Re: Turkey Point Units 3 and 4  
Docket Nos. 50-250 and 50-251  
Response to NRC Request for Additional Information Regarding  
Extended Power Uprate License Amendment Request No. 205 and  
Reactor Systems Issues

**RESPONSE TO NRC RAI REGARDING EPU LAR NO. 205  
AND SRXB REACTOR SYSTEMS ISSUES**

### Response to Request for Additional Information

**Figure SRXB-1.3.7.a-1**  
**Steam System Piping Failure at Hot Zero Power – 1.388 ft<sup>2</sup> Break**  
**without Offsite Power Available**  
**Nuclear Power and Core Heat Flux vs. Time**

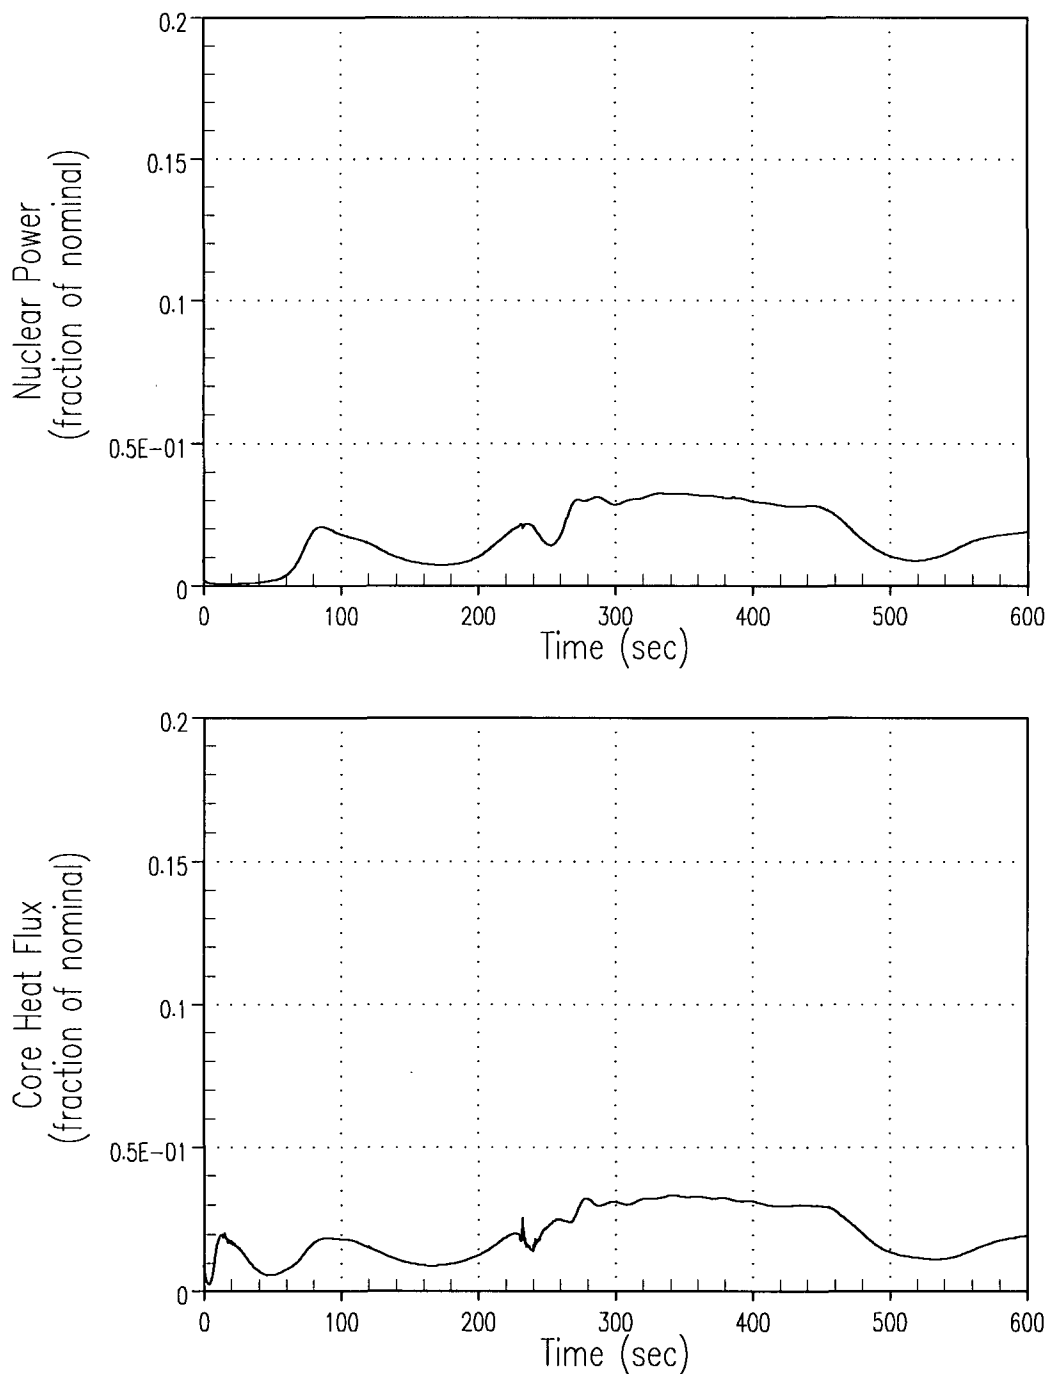
- a. LR §2.8.5.1.2.2.1.2 states that, "Cases were analyzed both with offsite power available (full coolant flow is maintained) and with a coincident loss of offsite power (causing the reactor coolant pumps to coast down 3.0 seconds following the break)." Provide the results of the analysis of the major rupture of a steam pipe at HZP, without offsite power, to show that the above design criterion is satisfied. Include a sequence of events table indicating the times and values of peak heat flux and minimum DNBR, and transient plots that are comparable to the reported results of the equivalent steamline break case with offsite power. Include a transient plot of core flow.**

The sequence of events for the analysis of a major rupture of a steam pipe from HZP conditions, without offsite power, is provided in Table SRXB-1.3.7.a; the transient plots for this case are provided in Figures SRXB-1.3.7.a-1 through SRXB-1.3.7.a-8. The value for the peak core heat flux in this case is 0.0334 (fraction of nominal); given the non-limiting nature of the overall plant response for this case in comparison to the case in which offsite power is available (reactor coolant pumps continue to operate), no detailed calculation of the minimum DNBR was performed for the case without offsite power. The analysis demonstrates that the results of the case with a coincident loss of offsite power are bounded by the more limiting

**Figure SRXB-1.3.8.b-1**  
**Main Steamline Depressurization at Hot Zero Power**  
**Steam Flow and Core Average Temperature vs. Time**

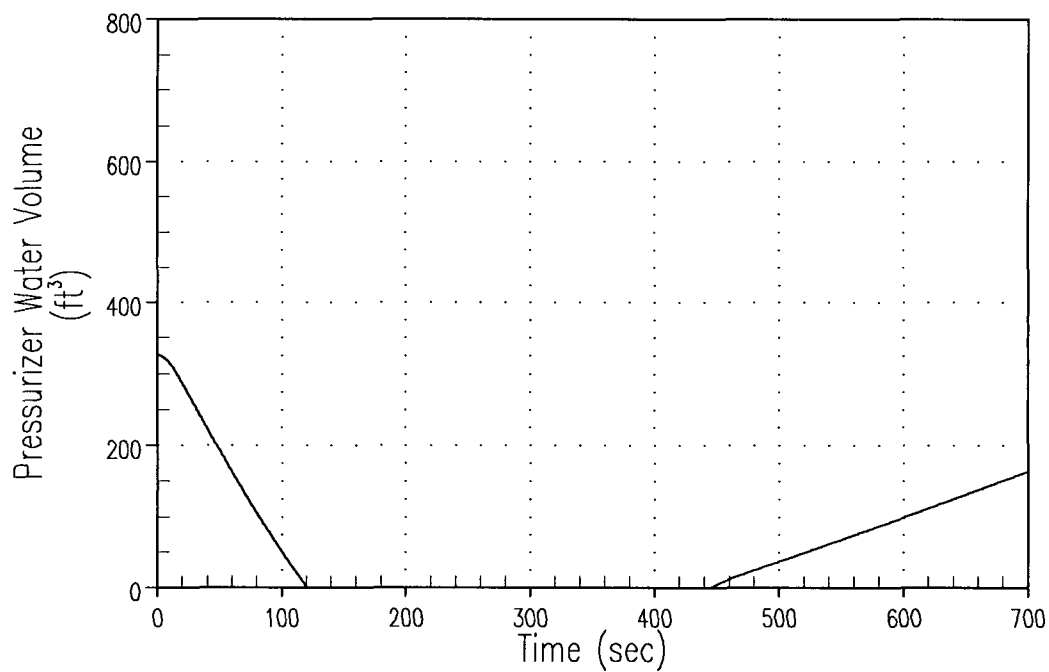
- b. Provide the analysis results of a credible steam line break, including a time sequence of events table listing values for peak heat flux and minimum DNBR (if applicable) as well as their times of occurrence. (If question 1 (above) is answered, then this question is withdrawn.)**

For the analysis of a main steamline depressurization (i.e., credible steamline break) at Hot Zero Power conditions, steam flow was assumed to initially increase to approximately 8% of the total full power steam flow (approximately 255 lbm/sec at 1000 psia), which bounds the flow increase resulting from the inadvertent opening of any single steam system valve (steam dump, steam relief or steam safety valve). The sequence of events resulting from this analysis is provided in Table SRXB-1.3.8.b; the transient plots for this analysis are provided in Figures SRXB-1.3.8.b-1 through SRXB-1.3.8.b-3. As shown in Figure SRXB-1.3.8.b-2, there was no return to criticality predicted for this event. Therefore, no detailed calculation of the minimum DNBR was performed for the main steamline depressurization analysis.

**Figure SRXB-1.3.11-1**  
**Steam System Piping Failure at Hot Zero Power – 1.388 ft<sup>2</sup> Break**  
**with Offsite Power Available and without Accumulator Boron Credited**  
**Nuclear Power and Reactivity vs. Time**

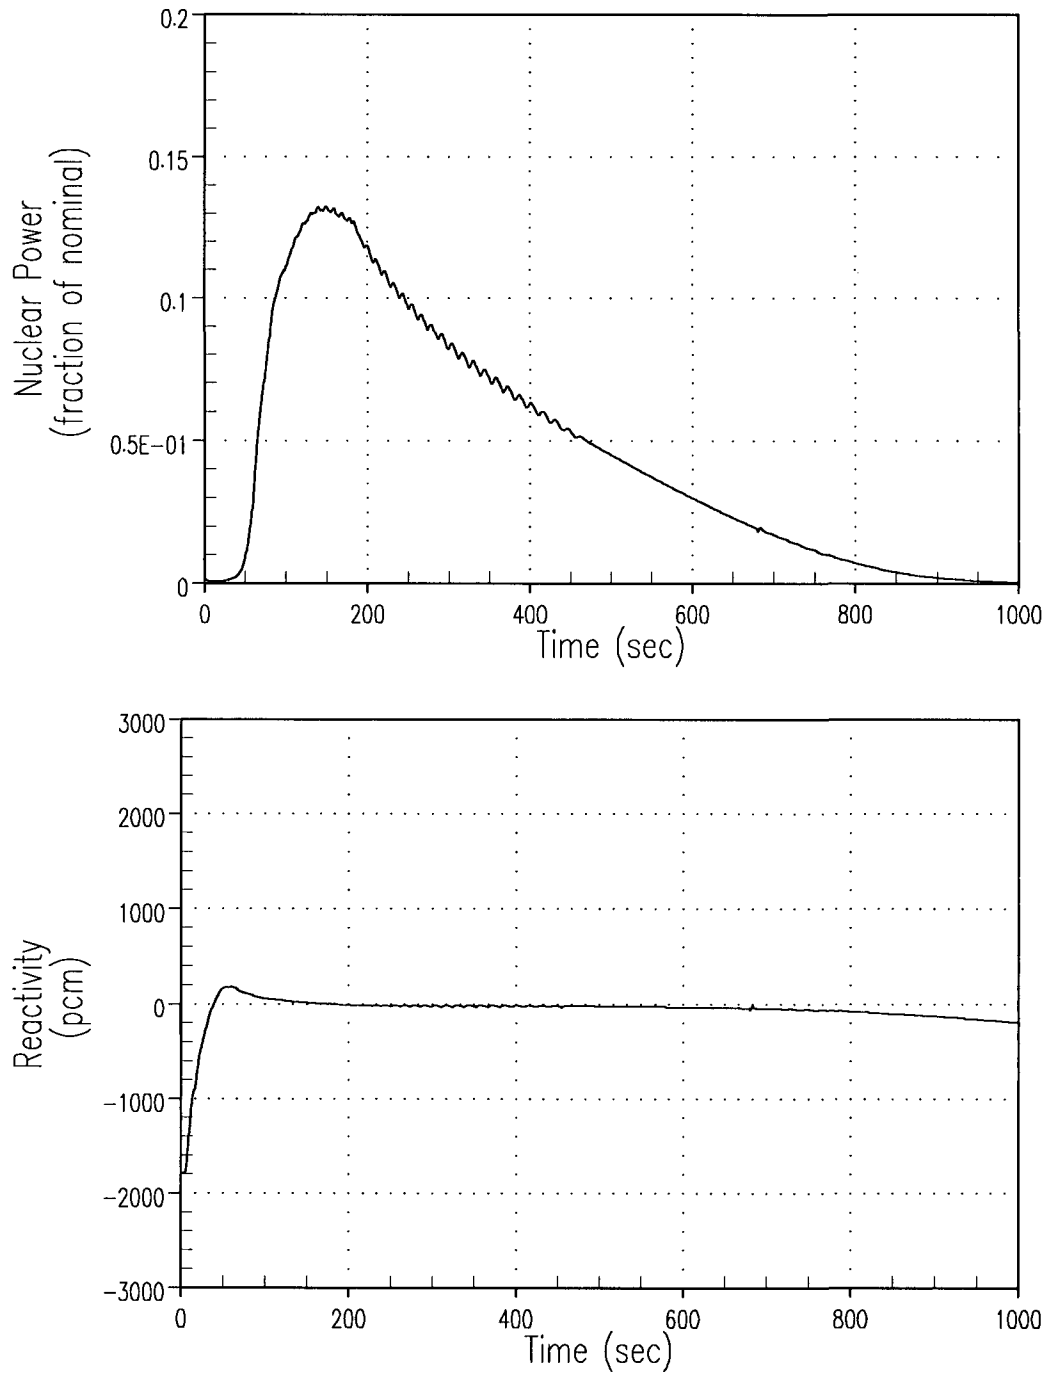
**SRXB-1.3.11** Table 2.8.5.1.2.2.1-1 indicates the core becomes subcritical at 186.25 seconds. Why is nuclear power still being generated, at a rate greater than 3%, more than six minutes after the core becomes subcritical?

The negative reactivity insertion resulting from the addition of boron to the core from the SI flow injection does cause the core to become subcritical by 186.25 seconds. However, given the conservatively low boron worth and SI flows assumed, the rate of change of reactivity is relatively slow and it is not until later in the transient that the overall reactivity of the core begins to decrease well below the point of criticality (see Figure SRXB-1.3.11-1). As such, it is also not until later in the transient that nuclear power approaches zero (see Figure SRXB-1.3.11-1). If the addition of boron from the accumulators had also been credited in the analysis, then the overall reactivity and nuclear power response would have decreased at a much faster rate (see Figure SRXB-1.3.11-2).

**Figure 1.3.14-1 - Simplified sketch of the shared HHSI system. (“S” identifies components that automatically change state on SI signal – i.e., valves open and pumps start)**

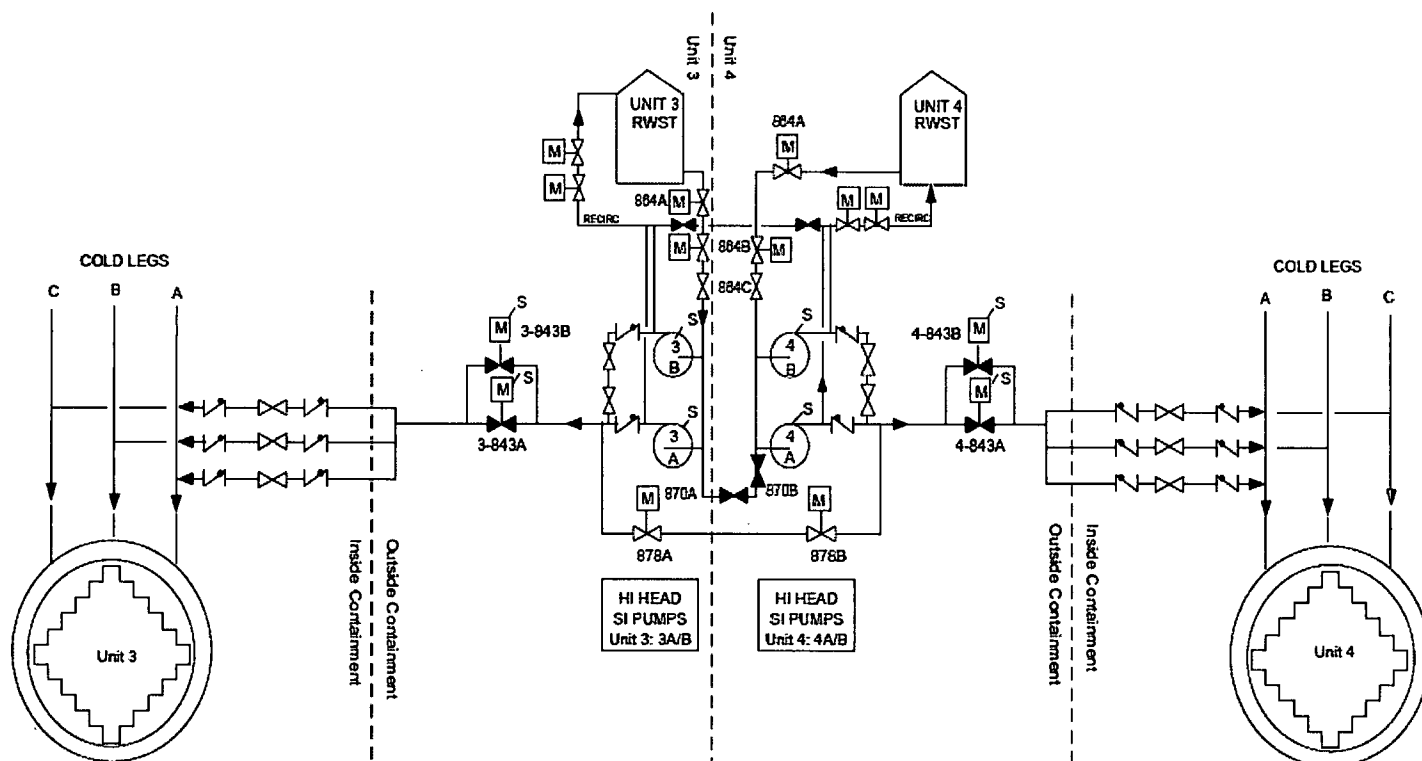
**c. If an SI signal is generated in one unit, what is the destination of the SI flow that is pumped in the other unit?**

If a SI signal is generated on one unit, both units’ HHSI pumps will start. As shown in Figure 1.3.14-1, the HHSI pump discharges are cross-connected between the two units. The SI signal opens only the accident unit’s cold leg injection valves, so all four HHSI pumps will deliver injection flow to the unit that generated the SI signal. Since the SI signal only opens the accident unit’s injection valves, no SI flow is delivered to the non-accident unit.

Figure 1.3.14-2

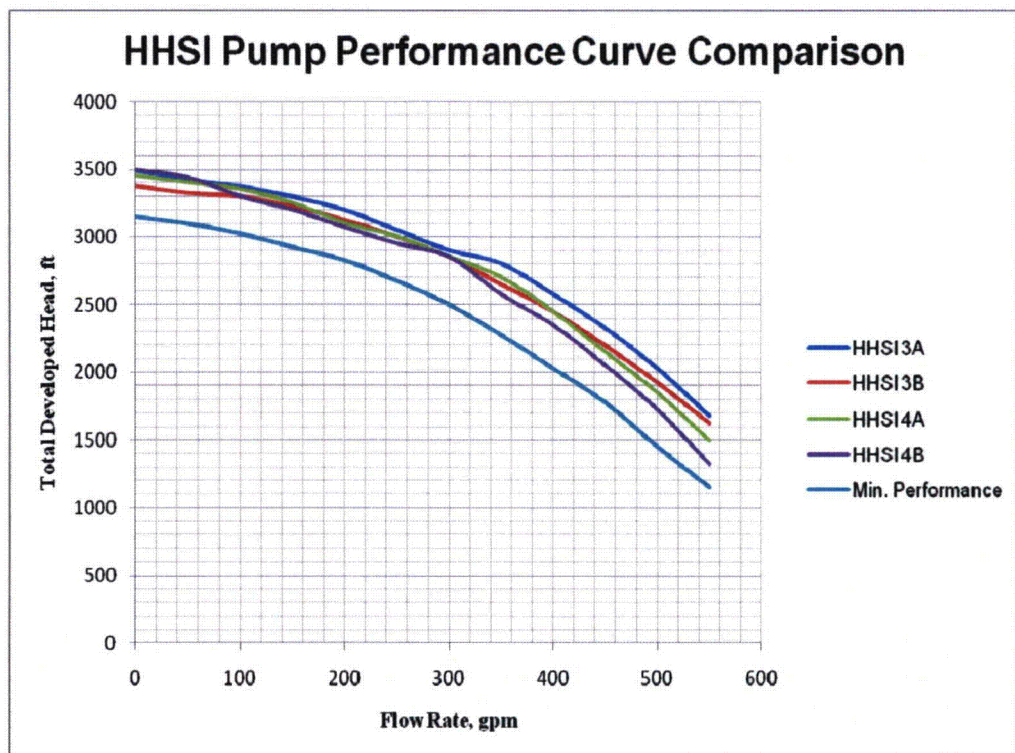
- d. **Why are the HHSI pumps assumed to be operating on degraded performance curves? Provide the degraded performance curves. Compare the degraded performance curves to the design performance curves.**

The minimum (degraded) performance curve shown in Figure 1.3.14-2 is used in the Emergency Core Cooling System (ECCS) analysis for all four HHSI pumps. The design performance curves for each of the four HHSI pumps are also shown in Figure 1.3.14-2.

The analysis conservatively assumes a minimum (degraded) performance curve to minimize the rate of negative reactivity injected to the core from the higher boron concentration of the Refueling Water Storage Tank (RWST) in the analysis of the Rupture of a Steam Pipe (Licensing Report (LR) Section 2.8.5.1.2) and to minimize core cooling flow in the analysis of Loss of Coolant Accident (LR Section 2.8.5.6.3). The ECCS minimum flow calculation assumptions include identifying the minimum (degraded) performance curve which identifies a lower pump head and flow curve to minimize core flow. The pump minimum (degraded) performance curve is degraded to be consistent with the plant pump surveillance procedures. These procedures account for Emergency Diesel Generator (EDG) underfrequency, pump degradation, etc. The minimum degraded pump curves are analytical limits which establish lower pump performance limits for acceptable operation for the installed plant pumps. There is no regulatory guidance to degrade the minimum performance curve.
